Land off Victoria Avenue, Whitefield, Manchester, M45 6DP

Supporting Statement

Condition 15

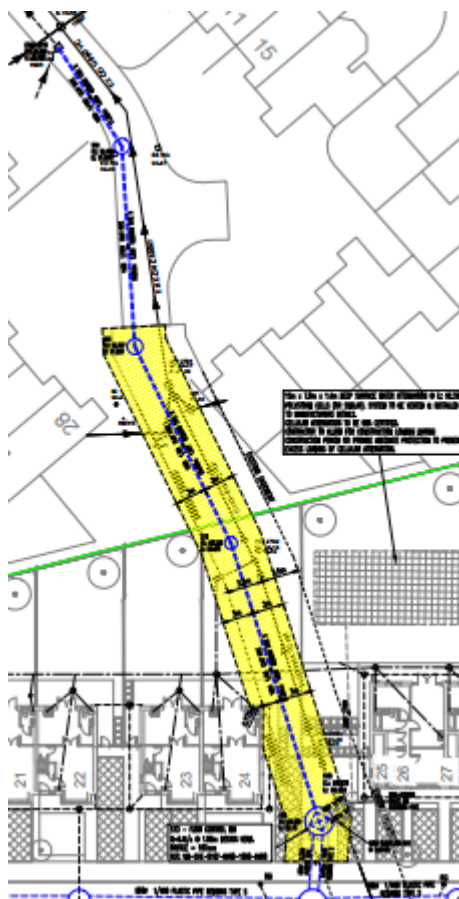
We would like the approval to read that the project should be carried out in accordance with 31990-SUT-ZZ-XX-DR-C-6200-P07 rather than P02.

This was because it was not possible to construct the drainage through the offsite shared driveway adjacent to our site due to existing MH constructions and services within that driveway.

The LLFA visited site and agreed that it was unfeasible to construct the proposed drainage as originally requested by United Utilities.

United Utilities agreed with the LLFA statement and allowed a connection to the combined sewer within the site.
